**Technical Service
Information Bulletin**

Title:
**TILT/TELESCOPIC STEERING
NOISE/SMOOTHNESS IMPROVEMENT**

Models:
'98 – '03 LX 470

**STEERING
ST002-04**

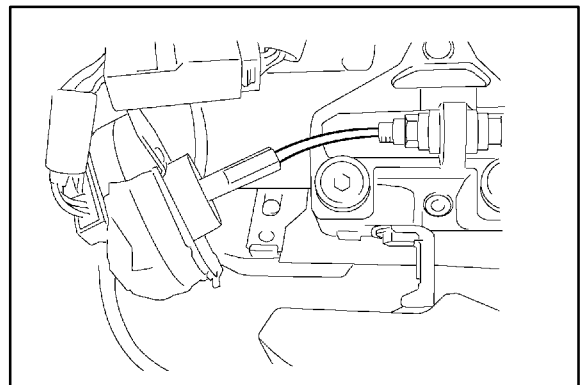
2. **Remove Telescopic Steering Column Cable Assembly.**
 - A. Remove the telescopic steering column cable.

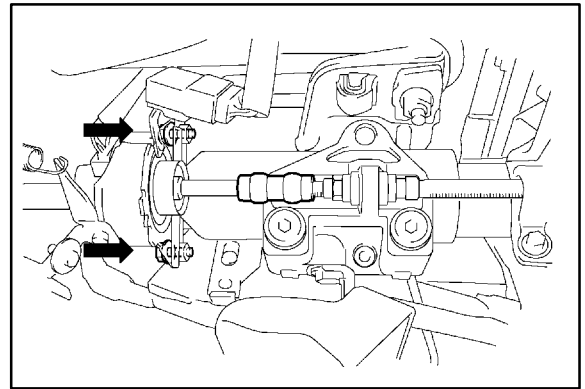
Introduction Some 1998 – 2003 model year LX470 vehicles may experience steering column noise. The cable has been replaced with a universal joint to reduce the steering column noise. Follow the repair procedures described below.

- 3. Install Steering Shaft Universal Joint Assembly.**
 - A. Install the steering shaft universal joint assembly.
 - B. Tighten the power telescopic motor with 2 bolts.
- Torque: 9 N•m (90 kgf•cm, 78 in.•lbf)**
